## REP7-XXX RHS Responses to ExQ3

Appendix 1 Detailed RHS response to Q3.4.1

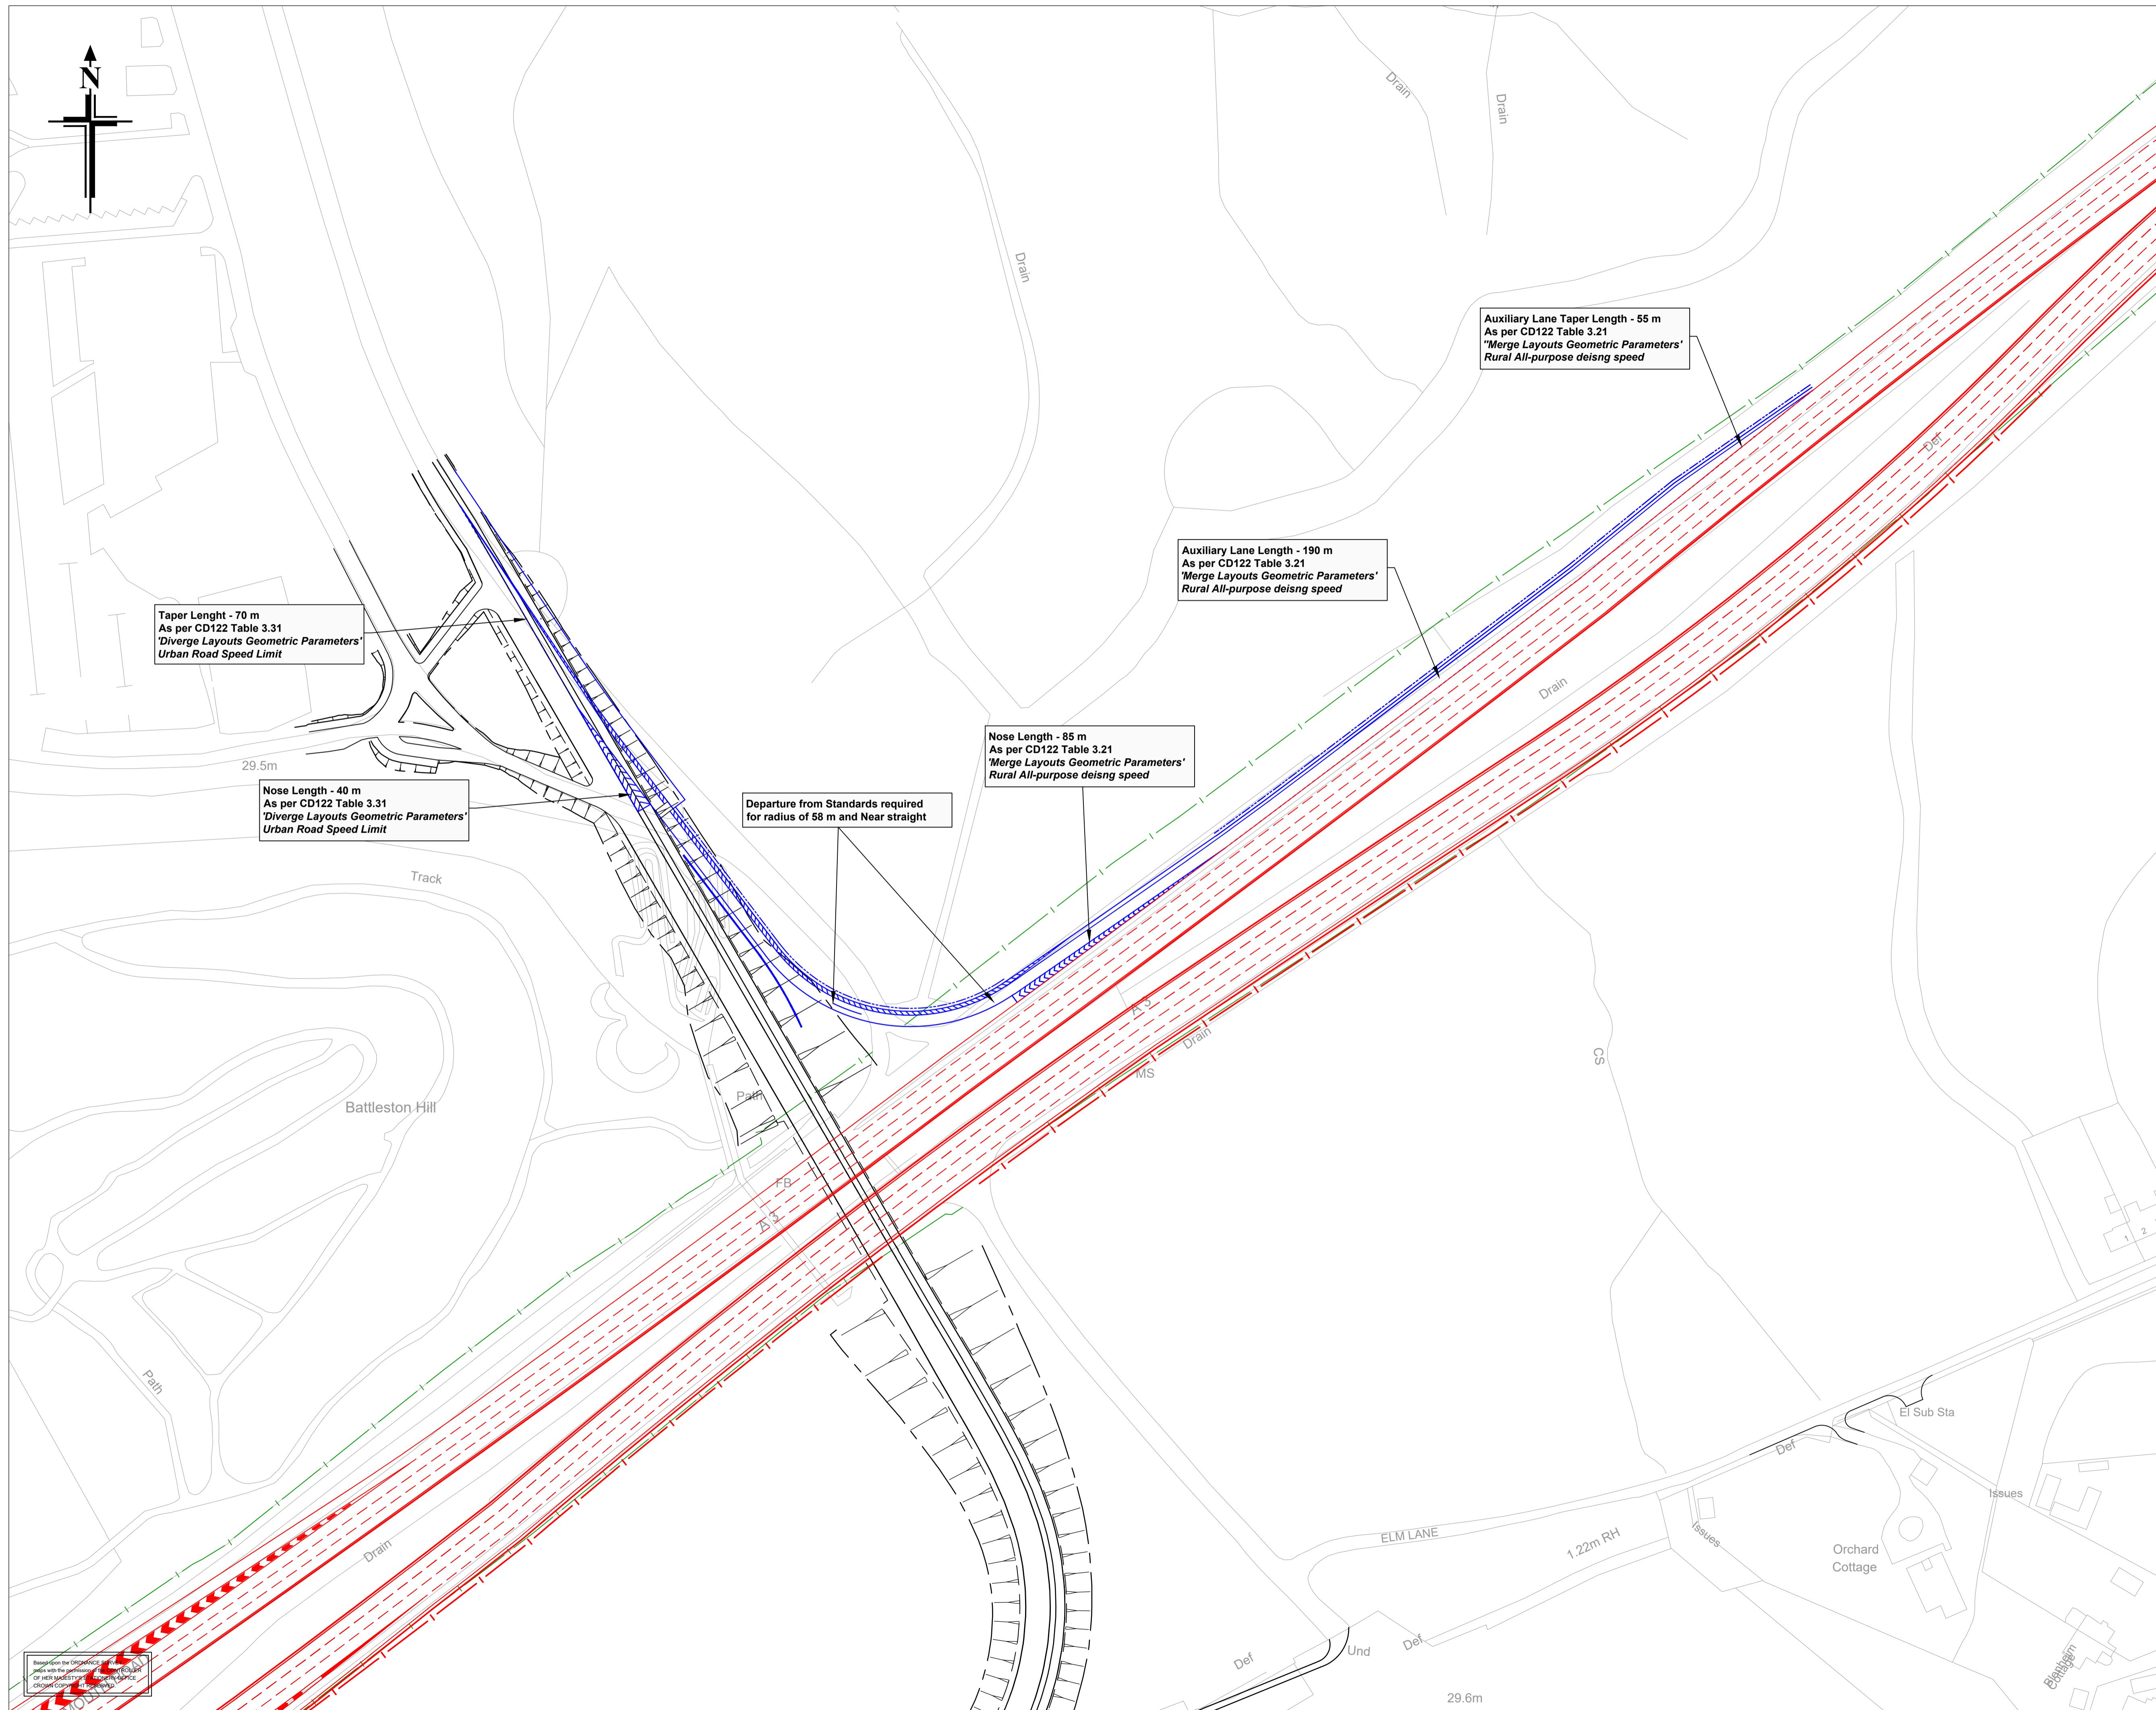
13.	<b>Traffic, Transport and Road Safety</b>	
Q3.13.7	Applicant & RHS	<p>In response to the ExA's SWQ 2.13.14 you have provided conflicting answers as to whether the 'RHS Alternative' access arrangement would include an at grade or grade separated junction between Wisley Lane and the A3. It appears to the ExA that unless</p> <p>For the purposes of responding to ExQ3 at Deadline 7:</p> <p>a) Please see the attached plan ("ExQ3.13.7 – Plan") which has</p>

<p>fundamentally different design assumptions are being made about what form a 'left out' junction from Wisley Lane might take that such a junction could only be either at grade or grade separated.</p> <p>The Applicant and the RHS are therefore requested to:</p> <ul style="list-style-type: none"> <li>a) agree between one another hypothetically what form of junction or junctions could physically be accommodated; and</li> <li>b) then advise the ExA which of DMRB CD122 or CD123 would any such junction design or designs need to be assessed against. Should any junction design or designs require a relaxation from the relevant design standards to be applied, the Applicant and the RHS are requested to explain the nature of any relaxation that would be required.</li> </ul> <p>The response to this question is one which the ExA expects the Applicant and the RHS should include in their SoCG, with clear explanations for matters that are or are not agreed.</p>	<p>been shared with HE along with the following explanation (a response is awaited).</p> <p>b) CD122 provides the following definition of a grade separated junction:</p> <p>"A grade separated junction has at least two carriageway links at different levels, and usually involves the provision of a structure to accommodate carriageways crossing."</p> <p>The RHS Alternative Scheme satisfies this definition.</p> <p>The RHS invited HE to agree this information but it was not able to do so by Deadline 7 so this is the RHS answer to the question - not an agreed or disagreed position with HE. A response to this question will be included in the SoCG on the basis required by the ExA.</p>
